AMENDMENT NO. 1 DECEMBER 2024
TO
IS/IEC TR 60269-5 : 2014 LOW-VOLTAGE FUSES
PART 5 GUIDANCE FOR THE APPLICATION OF LOW-VOLTAGE FUSES

This amendment to Indian Standard IS/IEC TR 60269-5 : 2014 is identical to Amendment No. 1 (2020) to IEC TR 60269-5 : 2014 issued by International Electrotechnical Commission (IEC).

Figure 17 – Inverter double-way connection with arm fuses for regenerative or non-regenerative load

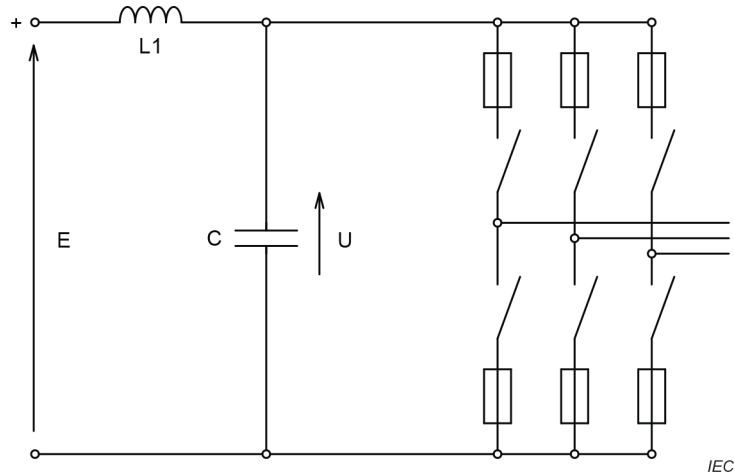
Add, at the end of Clause 15, the following new subclauses:

Figures 17 to 19 show examples of inverters of voltage source type.

- fuses in the arms of the inverter (Figure 17)
- fuses in the DC loop of the inverter (Figure 18): fuse current rating is $\sqrt{3}$ times the current rating of the fuse in the arms
- fuses in the DC feeder (Figure 19): between the capacitor and rectifier
- (or another kind of DC power supply)

Figure 19 – Multi inverters systems double-way connection with d.c. loop fuses for regenerative or non-regenerative load

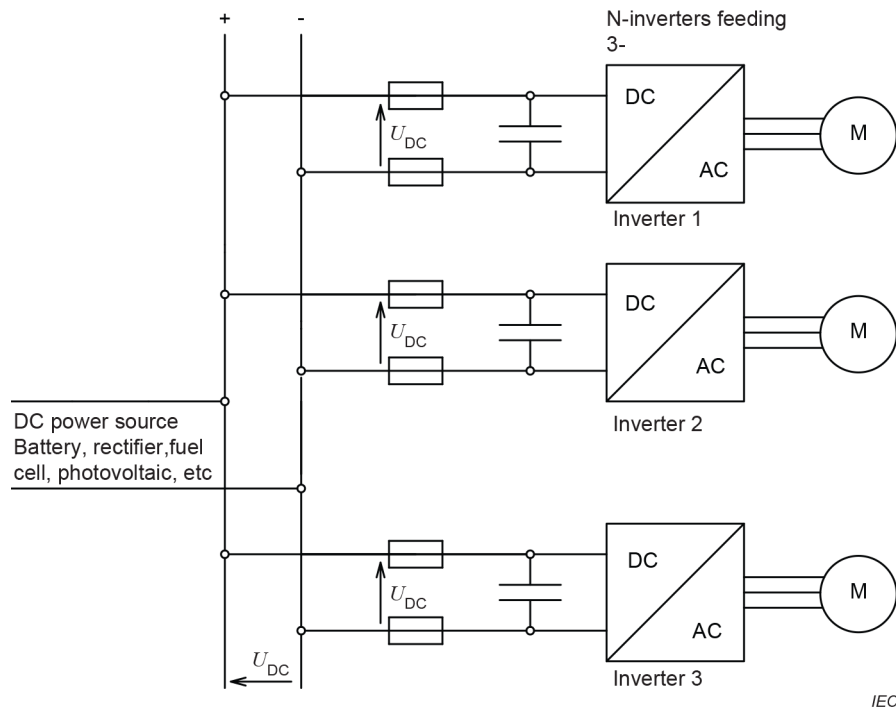
In case of multi-inverters systems (Figure 19) the fuses are installed on the DC side of each inverter and will interrupt the capacitor discharge currents from all capacitors in all other feeders (they are in parallel) and the DC current supplied by the DC power source. The fuse selection is based on the knowledge of the fuse-link maximum DC voltage rating at time constants lower than 1 ms.

Figure 20 – Capacitor discharge

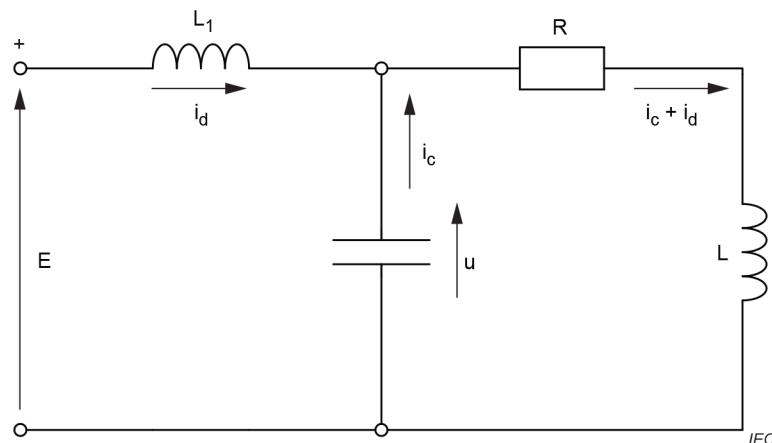
The fuse-link will operate very quickly as the di/dt is generally very high because of the very low value of the inductance L_1 (see Figure 20).

When an IGBT or a GTO fails the capacitor is short-circuited and the fuse is protecting a circuit as described in Figure 20.

E	voltage value of the DC power source-
U	instantaneous value of the voltage across the capacitor
i_{cap}	instantaneous value of the fault current supplied by the capacitor
i_d	instantaneous value of the fault current supplied by the DC power source
L_1	total inductance of the capacitor discharge circuit
L_2	inductance between the DC power source and the capacitor
R	resistance of the capacitor discharge circuit
C	Capacitor

Figure 21 – Voltage across the capacitor

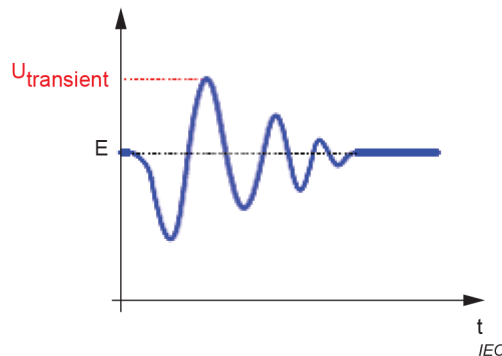
Just after the arc extinction, there is a transient phenomenon during the recharge of the capacitor by the power source producing an over voltage across the capacitor, the peak value of which is $U_{transient}$. This value is significantly above the initial value E (Figure 21).

Assuming there is no resistance in the circuit and assuming the capacitor has been fully discharged, the maximum theoretical value of this transient over-voltage is $2 E$.

The realistic value is: $U_{transient} = 1,75 E$

Figure 22 – Inductance of the circuit

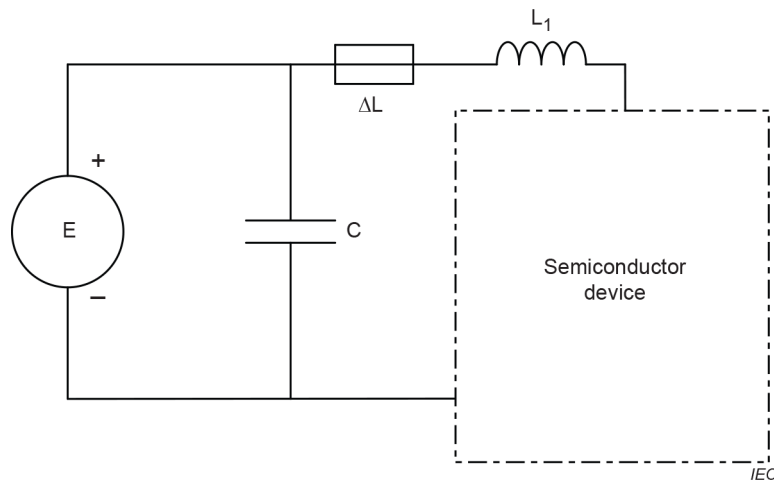
The L value of a circuit inductance depends mainly on the shape and length of the circuit. When the fuse is introduced into the circuit, it changes the length and the shape of that the circuit. Consequently the inductance L of the circuit becomes $L + \Delta L$ (Figure 22).

ΔL is not an inductance located inside the fuse having a constant value. Fuse manufacturers measured ΔL of several fuses with the circuit in Figure 22. The value of the circuit with fuse and without fuse is obtained by measuring the di/dt when the circuit is closed.

For these measurements the fuse is replaced by a copper bar in order to minimize the change of length of the circuit. The ΔL value drastically decreases when the body of the fuse is flat.
